REQUEST FOR PROPOSAL

Project Title: Cooley Laboratory Renovation
Location: Montana State University

PPA No.: 10-0023
RFP No.: 48
Date: May 15, 2012

Revise Sewer line @ tunnel intersection;

9
C1.4 **SEWER/UTILITY TUNNEL CROSSING**
(SCALE: 1"=2'-0")

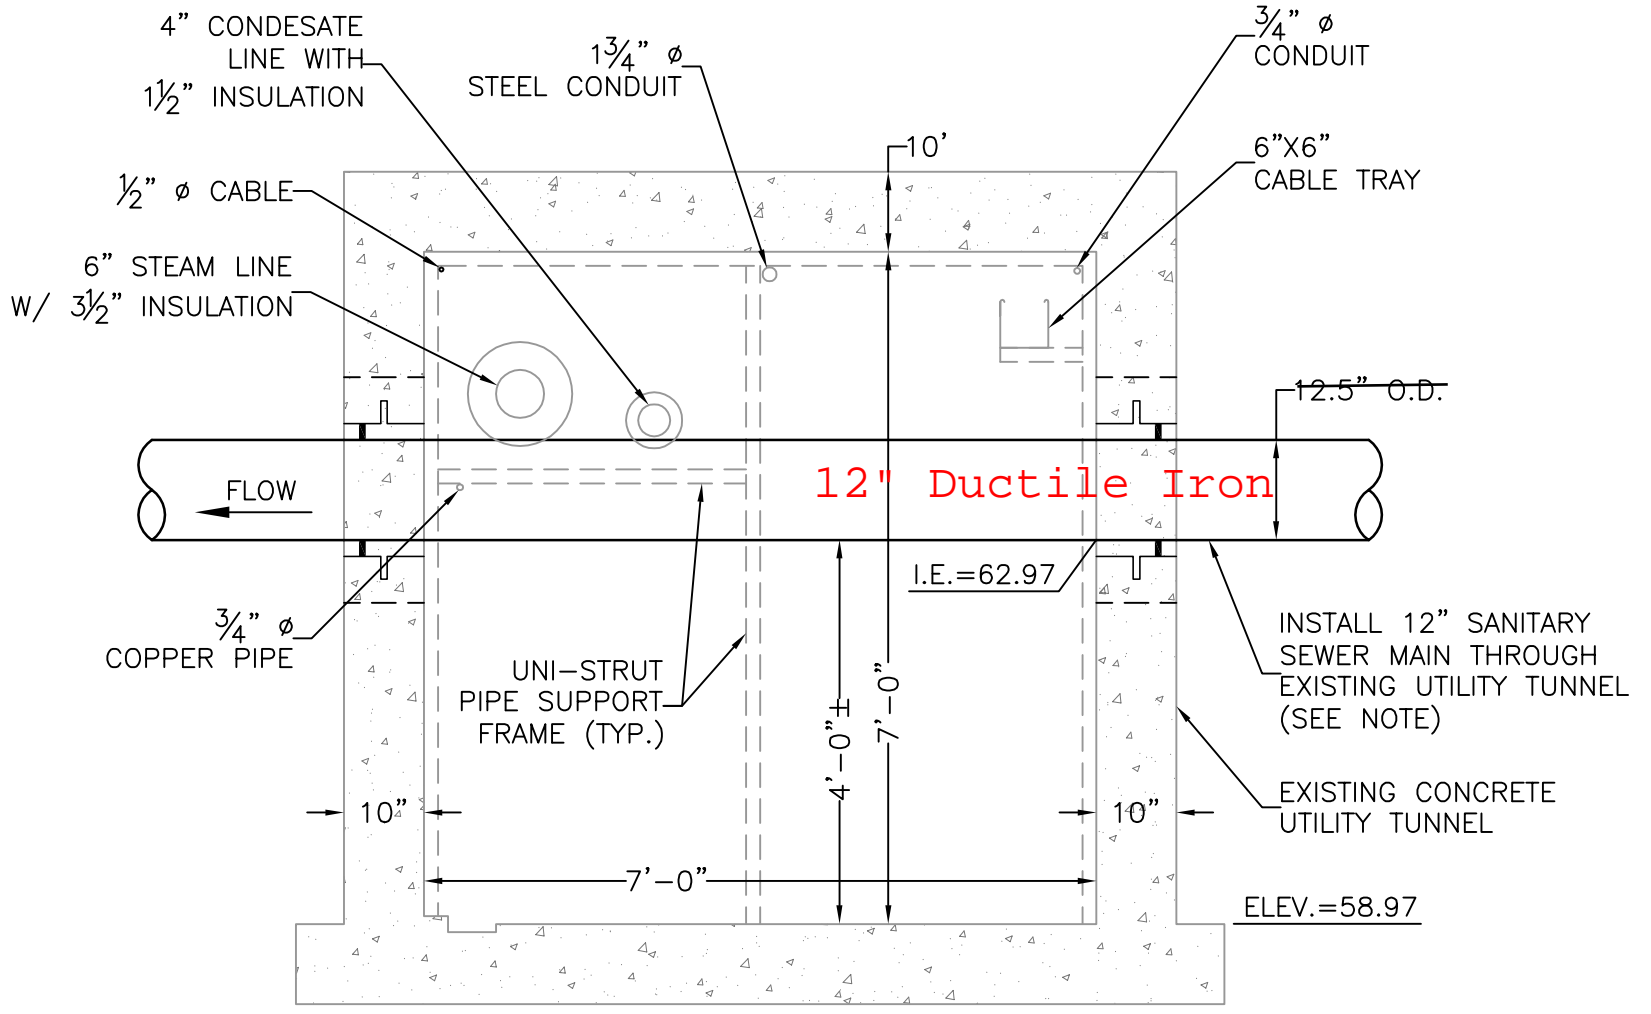
Sanitary Sewer line through tunnel shall be 12" Ductile Iron.
Delete 12 " SDR as shown on attached sketch and email from Morrison & Maierle.

- Ductile iron (DI) pipe shall be plain end both sides, 16' minimum length, centered through tunnel.
 - DI pipe to have standard cement lining for corrosion protection.
 - Offset the DI invert 0.03 feet lower than the PVC invert, to account for the larger inside pipe diameter.
 - Couplings shall be Fernco model 1251-1212, stainless steel bands & bolts.
- MHickman Email

- Ductile iron (DI) pipe shall be plain end both sides, 16' minimum length, centered through tunnel.
- DI pipe to have standard cement lining for corrosion protection.
- Offset the DI invert 0.03 feet lower than the PVC invert, to account for the larger inside pipe diameter.
- Couplings shall be Fernco model 1251-1212, stainless steel bands & bolts.
